**MONACO**  
COACH CORPORATION

Recall **07V016000** - US Units

**Re: Safety Recall - Wrong Screw used in Monitor**

### BACK LIP MONITOR CABLE CLAMP SCREW REPLACEMENT

Figure 1 Monitor in IP & in dash pod

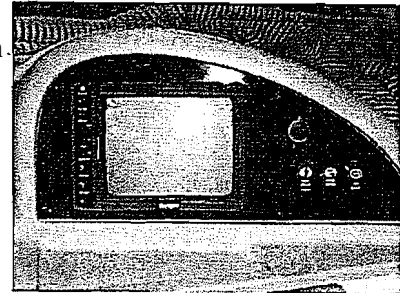
3. Remove the screws from the IP panel securing monitor to dash pod (Figure 1). Use care not to scratch or crack panel.
4. Pull the IP panel, monitor, and wires out of the dash pod so the monitor can be tipped forward and set on a shop towel without damaging the monitor or IP panel.
5. Locate rear clamp securing remote camera cables (Figure 2).
6. Remove the # 8 X 1" screw in position 3..
7. Install a # 8 X 1/2" screw in position 3 or position 4.
8. Reinstall monitor and IP panel. Reinstall screws using a hand-held screwdriver only (USE CAUTION NOT TO OVER TORQUE) (DO NOT USE A SCREWGUN).

Figure 2 Back of monitor & Cable Clamp

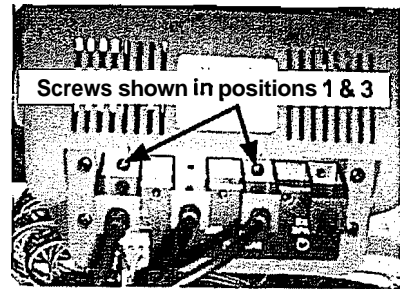
Monaco Coach Corporation determined that a production employee used the incorrect screw to install the black and white CRT back-up monitor in the dash. The incorrect screws are 1/4" longer than specified and may contact a PC board inside the monitor which could potentially hit a high voltage circuit on the PC board of approximately 10,000-13,000 volts. The monitor is located on the backside of the center dash console between the driver and passenger. If the screw makes contact with the high voltage tracer on the PC board and someone would touch the screw head with power on, this could result in an electrical shock. This screw is not visible or open to normal use area of the vehicle such as while driving or riding in the vehicle. The instrument panel would have to be removed or someone would have to be reaching under the dash to the back side of the panel to come in contact with the screw. As a precautionary measure, Monaco Coach Corporation has elected to perform this voluntary safety recall campaign.

Inspect operation of the back up monitor. Replace the cable clamp screw at rear of monitor if necessary.

**Kit contains:** **Kit A =** 1 - #8 X 1/2" screw (May Obtain Locally)  
**Kit B =** 1 - Back-up Monitor
